HIGHWAY WORK PROPOSAL

<u>COUNTY</u>	<u>STATE PROJECT</u>	<u>FEDERAL</u>	<u>PROJECT DESCRIPTION</u>	<u>HIGHWAY</u>
Fond Du Lac	1440-15-72	N/A	Fond Du Lac - Plymouth; Seven Hills Road-East County Line	STH 023
Fond Du Lac	1440-15-73	WISC 2020109	Fond Du Lac - Plymouth; Seven Hills Road-East County Line	STH 023

Addendum No. 01
 ID 1440-15-72/73
 Revised Sheet 7
 February 28, 2020

Addendum No. 01
 ID 1440-15-72/73
 Revised Sheet 104
 February 28, 2020

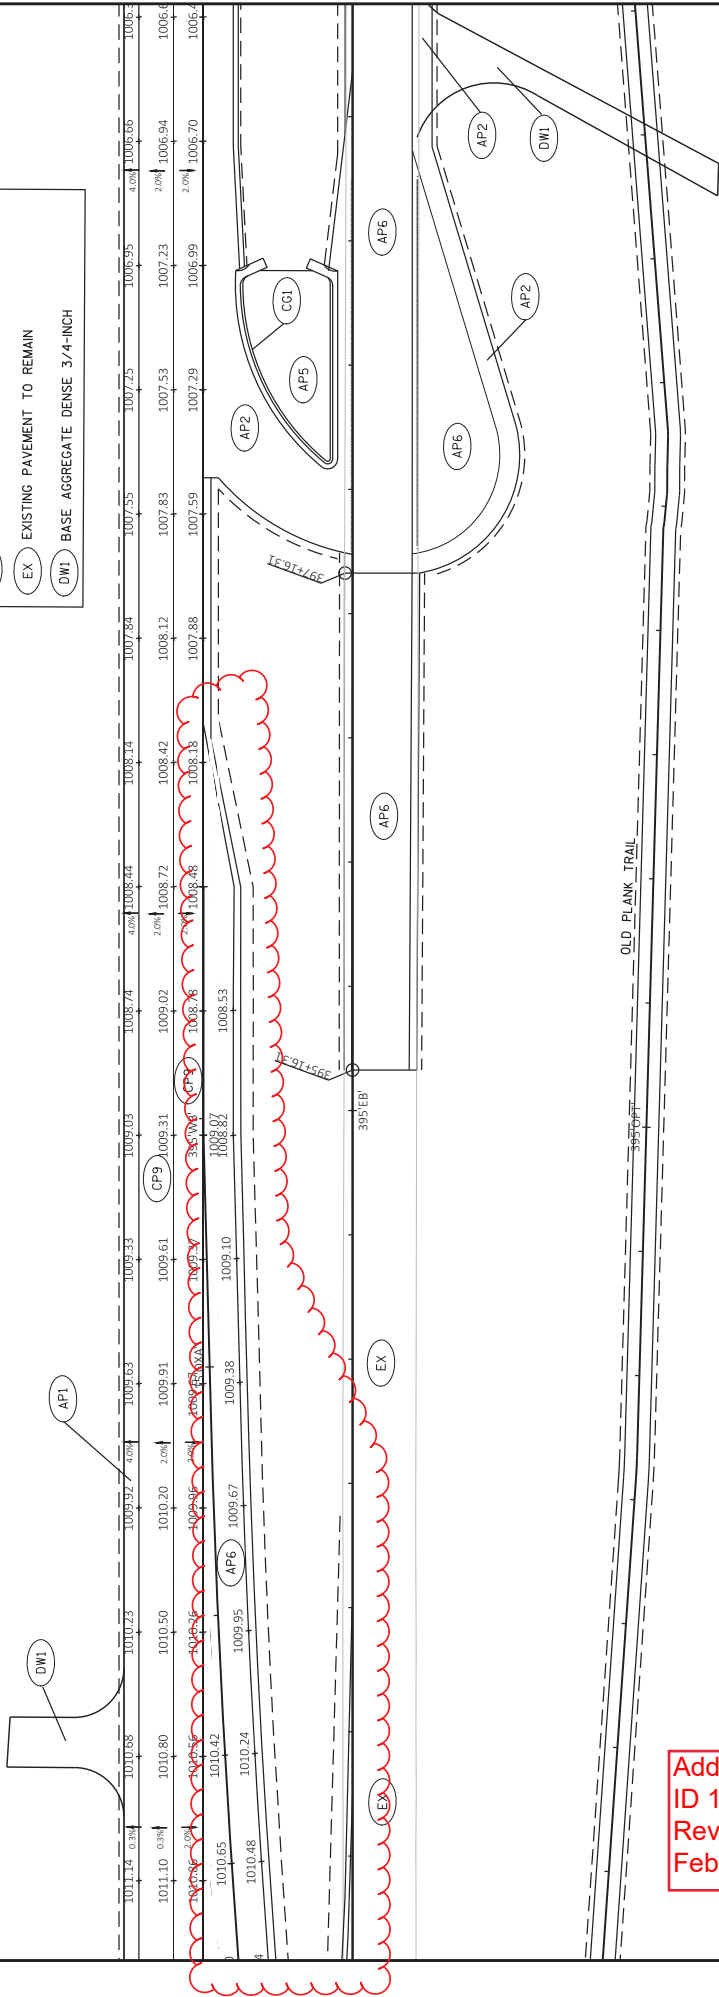
- LEGEND**
- (AP1) 3 1/2" HMA PAVEMENT 4 LT 58-28 S
 - (AP2) 1 3/4" HMA PAVEMENT 4 LT 58-28 H
 - (AP3) 3 1/4" HMA PAVEMENT 3 LT 58-28 S
 - (AP5) ASPHALTIC SURFACE 2-INCH
 - (AP6) 1 3/4" HMA PAVEMENT 4 MT 58-28 S
 - (AP7) 3 1/4" HMA PAVEMENT 3 MT 58-28 S
 - (CG1) CONCRETE CURB & GUTTER 6-INCH SLOPED 36-INCH TYPE D
 - (CP9) CONCRETE PAVEMENT 9-INCH
 - (EX) EXISTING PAVEMENT TO REMAIN
 - (DWI) BASE AGGREGATE DENSE 3/4-INCH

Addendum No. 02
ID 1440-15-72/73
Revised Sheet 479
March 5, 2020

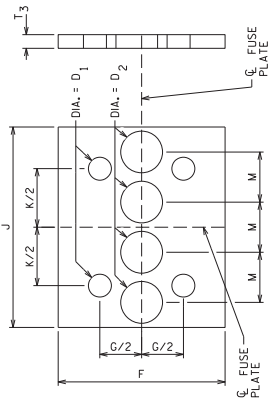
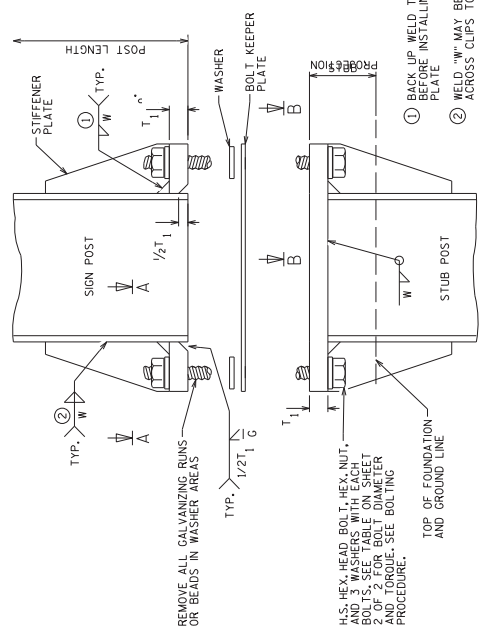
*THESE QUANTITIES ARE ESTIMATES.
ACTUAL SIZE/NUMBER/LENGTH/WEIGHT OF STEEL SUPPORTS/REINFORCEMENT/CONCRETE BASES
ARE TO BE DETERMINED BY CONTRACTOR, BASED ON SURVEY OF FIELD CONDITIONS, FINAL GRADE AND SIGN LOCATION.
SURVEY REQUIRED FOR DETERMINATION IS THE RESPONSIBILITY OF THE CONTRACTOR, INCIDENTAL TO THE CONTRACT.
FOLLOW SIGN DETAIL A-PLATES - A3-1, A3-2, A3-3, A4-1
